# MANDATORY SERVICE BULLETIN

## NO. MSB 42-076

This Service Bulletin prescribes the inspection of the firewall for holes that were drilled through the firewall composite structure during production process and if necessary the sealing of these holes.

### „Sealing of Holes in Firewall“

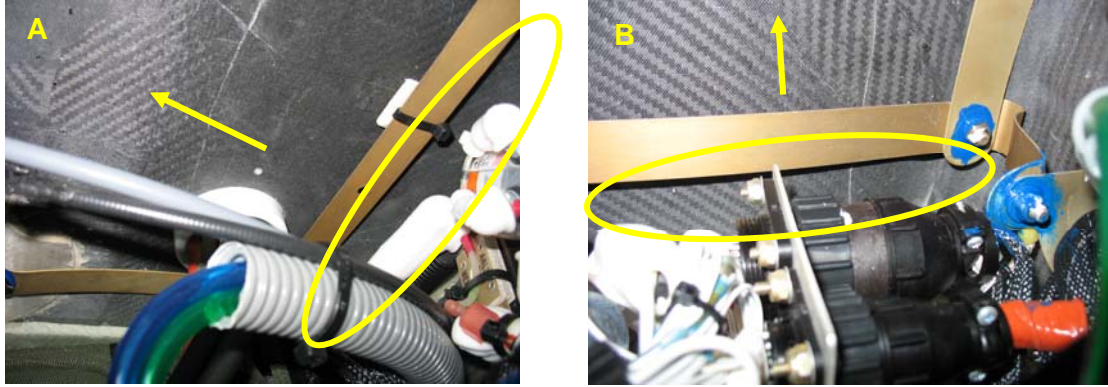
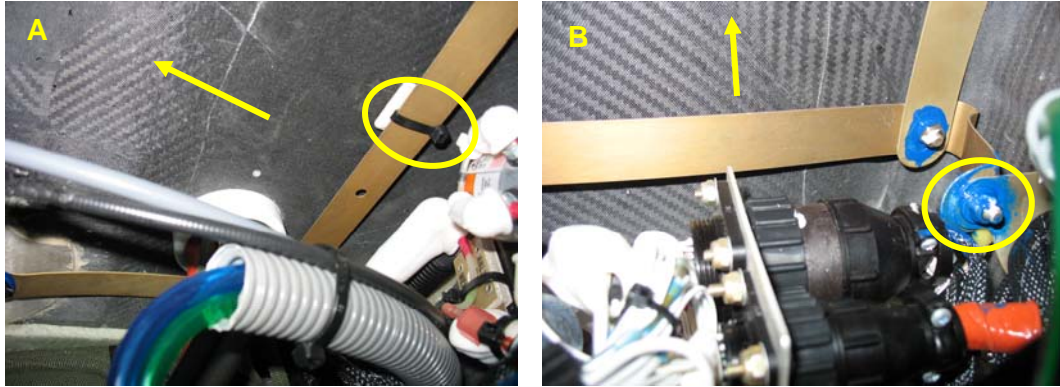
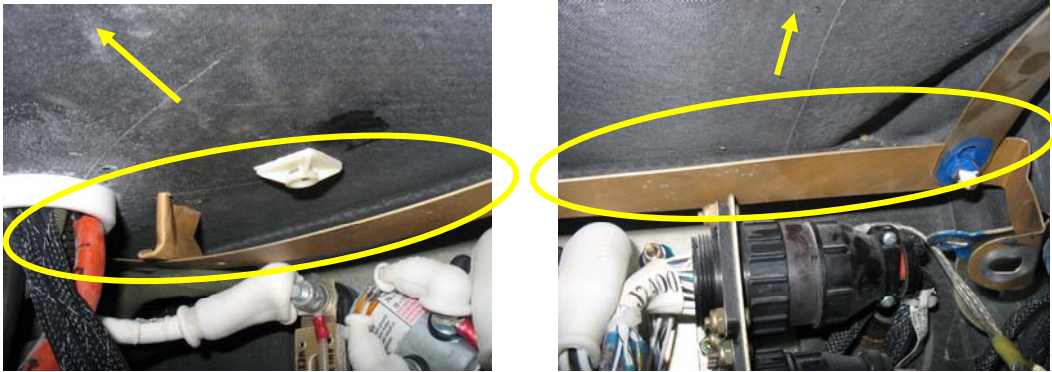
1	Remove the ECU access panel from the LH nacelle.
2	<p>The arrow in this picture indicates the bonding stripe in the ECU compartment of the LH engine. Along the area rear of and above the bonding stripe holes possibly might have been drilled through the composite structure during production process.</p>

3	<p>Inspect the area along the rear edge of the bonding stripe for holes with a diameter of approximately 4 mm that were possibly drilled into the composite structure. The arrows indicate the flight direction.</p> 
4	<p>If no holes are found continue with item 14.          If holes are found, typically four holes positioned in a line along the rear edge of the bonding stripe with a distance between 150 mm and 190mm from each other, continue with item 5.</p>
5	<p>Disconnect the airplane main battery for maintenance. Refer to AMM, section 24-31.</p>
6	<p>Remove the tie wrap (Picture A) and the screw that connects the bonding stripes and the bonding cable (Picture B). The arrows indicate the flight direction.</p> 
7	<p>Pull down the bonding stripe carefully. Inspect the composite structure above the bonding stripe and in the area rear of the bonding stripe for holes with a diameter of approximately 4 mm. Again the arrows indicate the flight direction.</p>  <p>Note : Use an appropriate spacer to hold down the bonding stripe.</p>
